SUBJECT: ISSUANCE OF AMENDMENT NO. 35 TO FACILITY OPERATING LICENSE NO. NPF-41, AMENDMENT NO. 22 TO FACILITY OPERATING LICENSE NO. NPF-51, AND AMENDMENT NO. 11 TO FACILITY OPERATING LICENSE NO. NPF-74, FOR THE PALO VERDE NUCLEAR GENERATING STATION, UNITS 1, 2, AND 3, RESPECTIVELY (TAC NOS. 68172, 68173 AND 68174)

SAFETY EVALUATION BY THE OFFICE OF NUCLEAR REACTOR REGULATION
RELATED TO AMENDMENT NO. 35 TO FACILITY OPERATING LICENSE NO. NPF-41,
AMENDMENT NO. 22 TO FACILITY OPERATING LICENSE NO. NPF-51
AND AMENDMENT NO. 11 TO FACILITY OPERATING LICENSE NO. NPF-74
ARIZONA PUBLIC SERVICE COMPANY, ET AL.
PALO VERDE NUCLEAR GENERATING STATION, UNIT NOS. 1, 2 AND 3
DOCKET NOS. STN 50-528, STN 50-529 AND STN 50-530

FIGURE 3.1-1
ALLOWABLE MTC MODES 1 AND 2
PALO VERDE UNIT 2 CYCLE 2

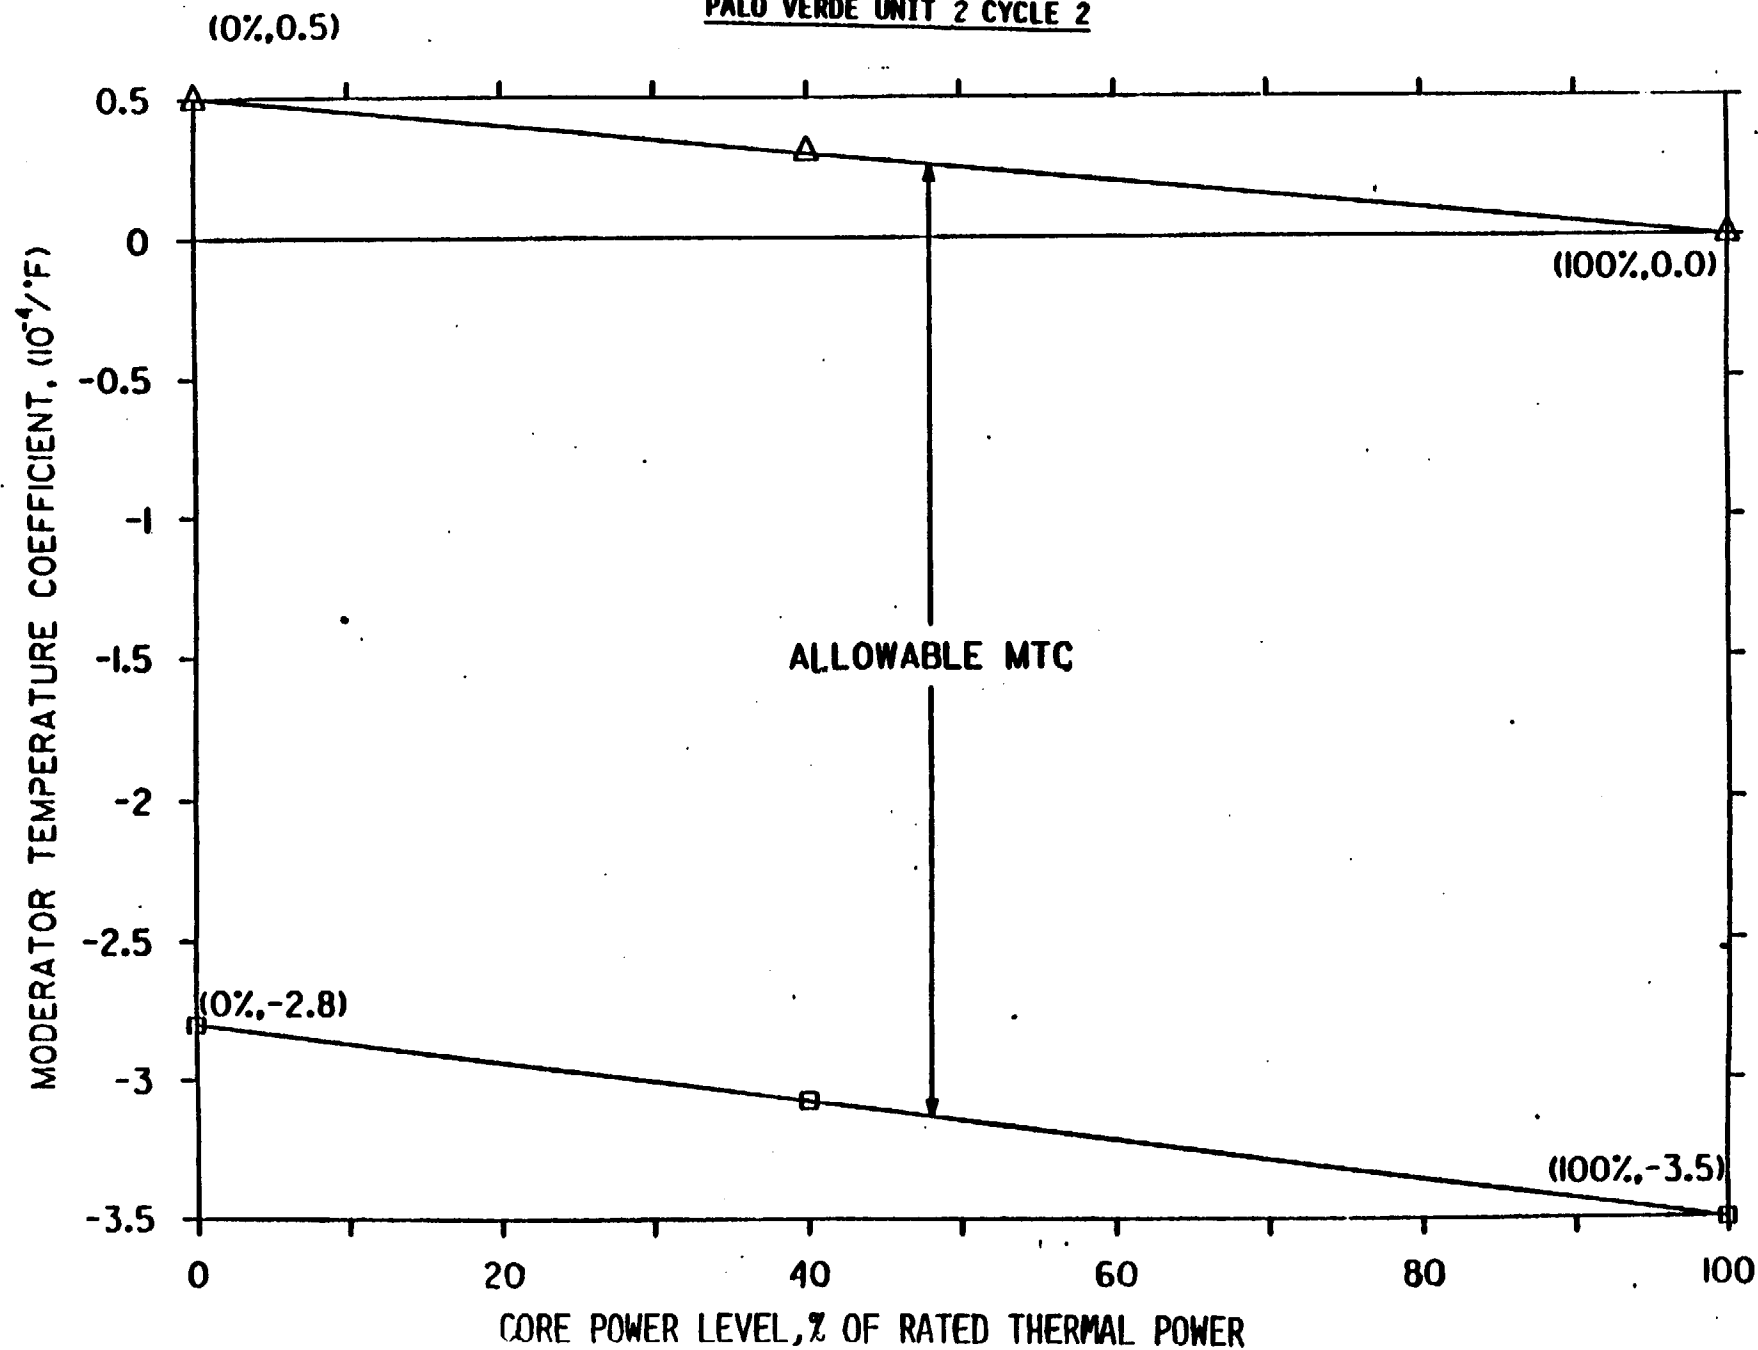
Also enclosed is a corrected Page 3/4 1-5 for the Palo Verde Unit 2 Technical Specifications. It was incorrectly captioned when it was revised in Amendment No. 19, dated May 5, 1988.
